Enhanced EH Format (Section 15.2.2.2)

Document Number:S80216m-09_2269

IEEE 802.16 Working Group Letter Ballot #30a (80216-09_0057)

Discuss and approve the proposed text changes into IEEE802.16m/D3 document

Figure 1: MAC PDU format

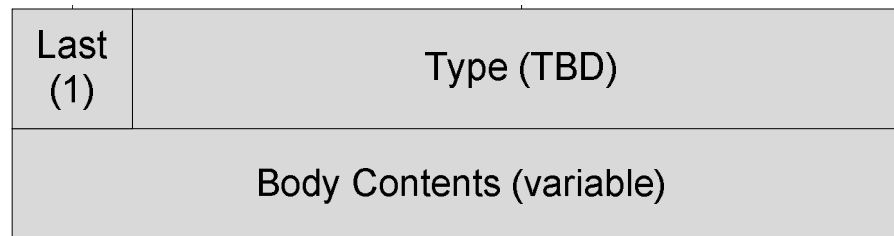
- The MAC PDU and extended header format in 16m (P802.16m/D2) is shown in Figure 1 and Figure 2 respectively
 - The EH format is variable in nature
 - The receiver can not decrypt the MAC PDU payload until it has parsed all the extended header
- In 16e, the extended sub header format contained the 'EH Length' which facilitated decryption of payload without parsing the extended sub headers

Figure 3: EH indication and FPEH/FEH presence

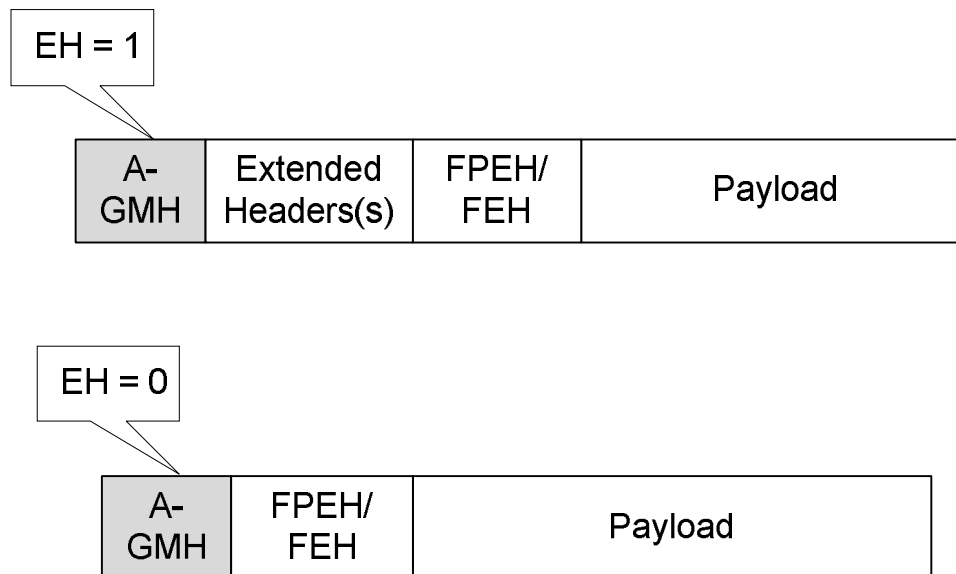
- FPEH/FEH issue
 - FPEH/FEH format is different from other EH format
 - Last & Type field are not defined
 - Extended header (FPEH/FEH) is present even when EH bit is '0' in AGMH

Figure 5: Proposed EH format

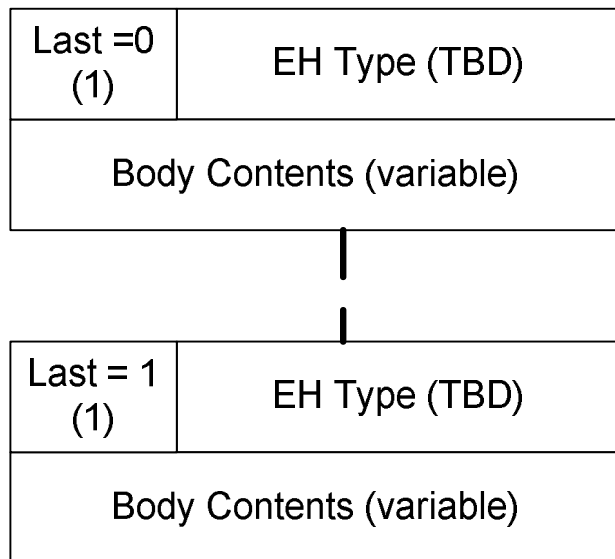
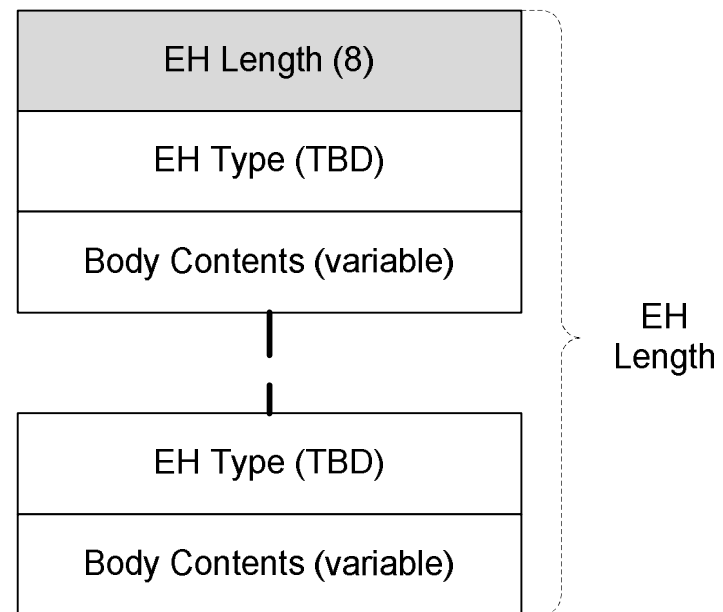
- The extended header format is shown in figure 5 below
 - All extended headers are of same format consisting of a type field followed by type specific fields
 - ‘Last’ bit is removed
 - The first extended header is preceded by 1 byte ‘EH Length’ field which gives the sum of length of all extended headers
 - The presence/absence of EH is indicated by ‘EH’ field in AGMH

Figure 7: FPSH and EH illustration

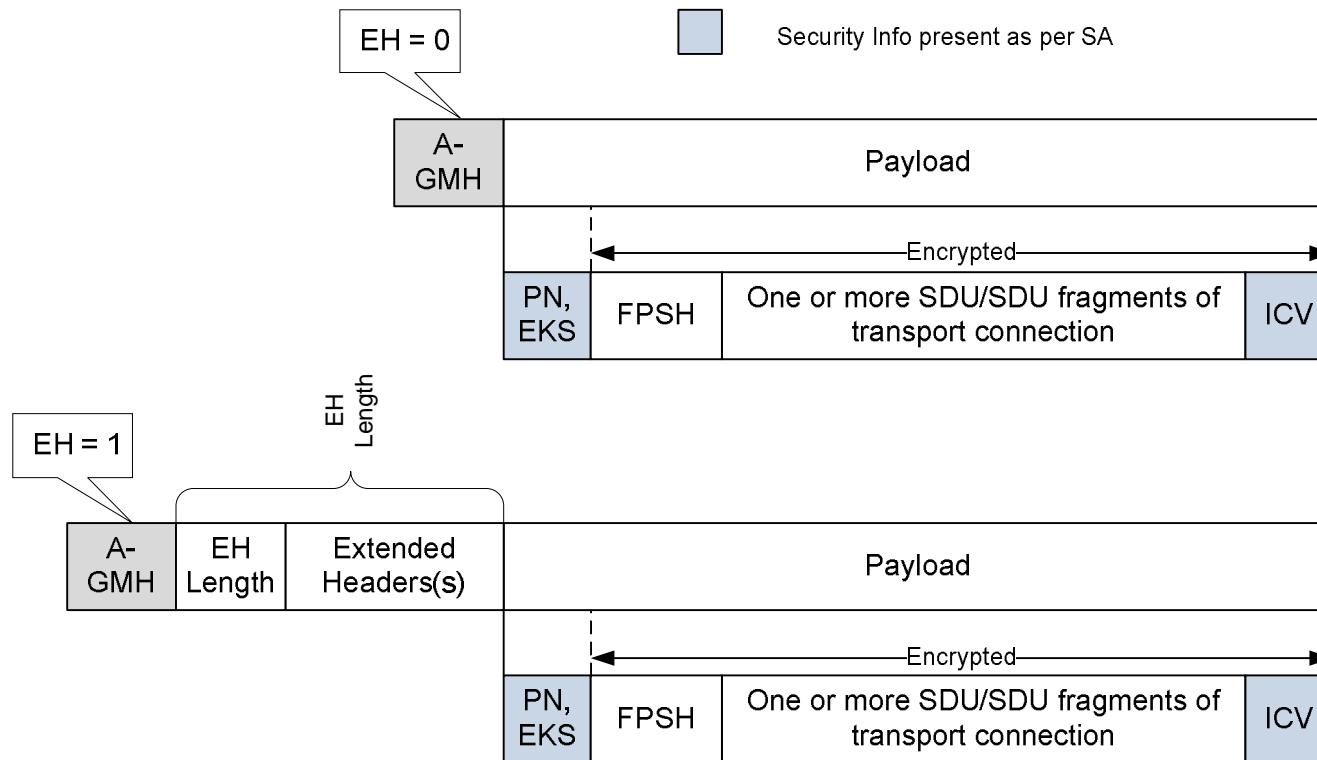
- FPEH is defined as Fragmentation & Packing sub header (FPSH)
 - Fields of FPSH are same as FPEH
 - FPSH is appended before the first SDU/SDU fragment in the transport connection payload (see figure 7)

Figure 8: FSH and FlowID illustration

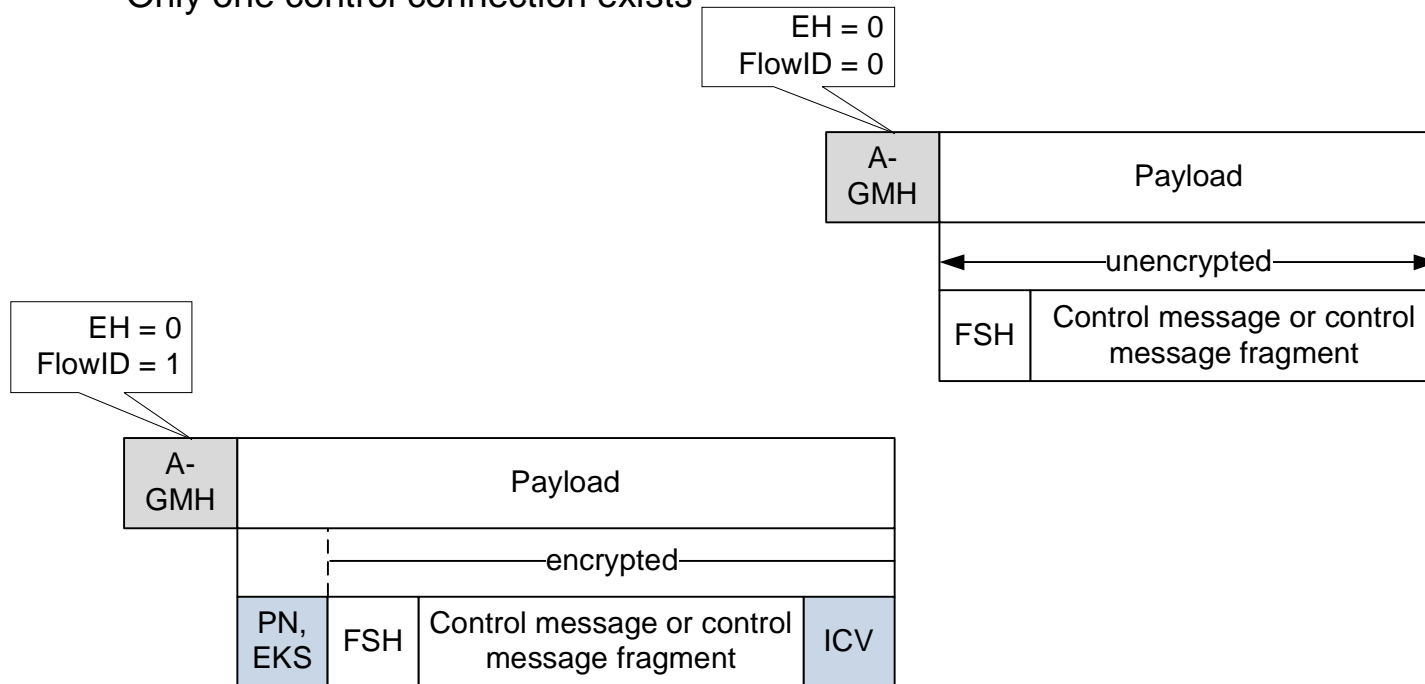
- FEH is defined as Fragmentation sub header (FSH)
 - FSH is appended before the control message or control message fragment in the control connection payload
 - Fields of FSH are same as FEH except the 'EC' bit
 - EC bit is removed from FSH
 - Flow ID is used to distinguish between the unencrypted and encrypted control message on the control connection
 - Only one control connection exists
